January 30, 2019

**Re: New Well and Tank (PR#46-2018)
 Camp Cooper BSA (PWS ID#92088)
 Site Plan Approval – Revised 1-30-19**

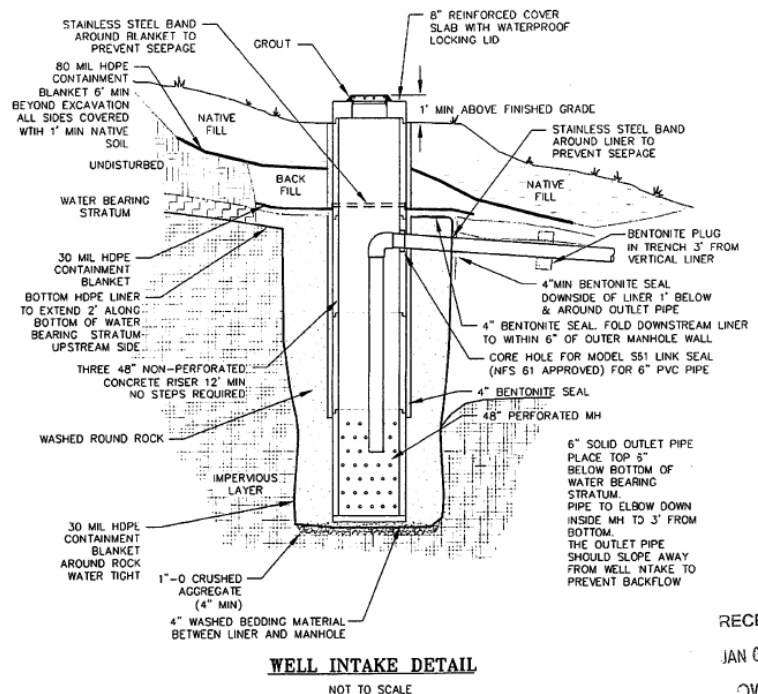
On April 4, 2018, our office received plans and a land use compatibility statement for a dug well and small poly tank. A plan review fee of \$825 was also received. Additional plans were received on April 6, 2018. Plans were subsequently revised and received on January 23, 2019. A Final Order dated January 9, 2019 was also issued by the Oregon Water Resources Department (OWRD) regarding a Special Standards Request for the revised well design (shown in the well detail at right) and received in our office on January 15, 2019.

Thanks for keeping me in the loop on this. Based on the diagram they provided, it looks like the only real change is the depth to the water-bearing stratum and the depth at which the 30 Mil HDPE – Bentonite cap will overlie the washed round rock. So, my original comments should still be valid – Since, based on the geology, this well can't be constructed to meet current OWRD standards, they should submit designs to OWRD and request a Special Construction Standard. If OWRD issues the Special Construction Standard, it should be included in the materials they submit to us, otherwise we won't be able to approve it for public water supply use. Note that due to the shallow nature of the water-bearing stratum, we are likely to require monthly raw water bacteria samples (to start) either as a part of distribution system monitoring or as source assessment monitoring if residual maintenance chlorination is to be continued.

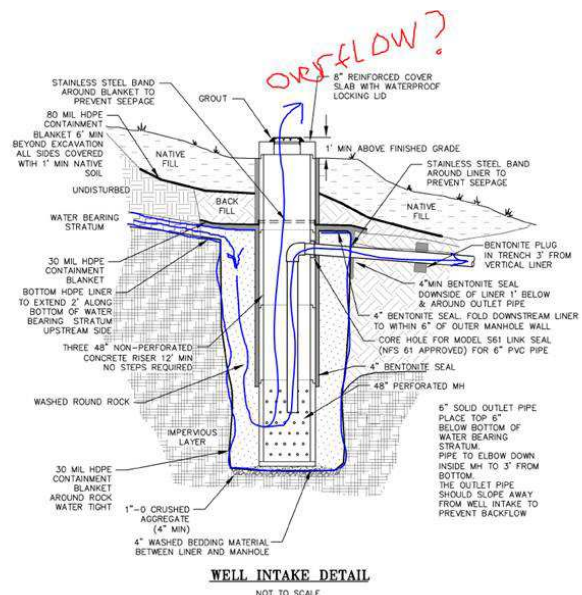
A method of determining the total output of the well must be provided (typically, this requirement is met by installation of a flowmeter.) Note that we can waive this requirement if the well is determined to be in a confined aquifer.

There are some concerns about the vulnerability of the flapper valve on the 6” line from the well. This will require ongoing routine maintenance to ensure the operation of the flapper valve is not compromised. Given the nature of the well construction, gravity flow, and site gradient, this overflow is needed to prevent water in the well from erupting out the lid (see sketch to the right) or disrupting the casing seal and containment blanket should demands be less than flow into the well and the downstream overflow flapper malfunction.
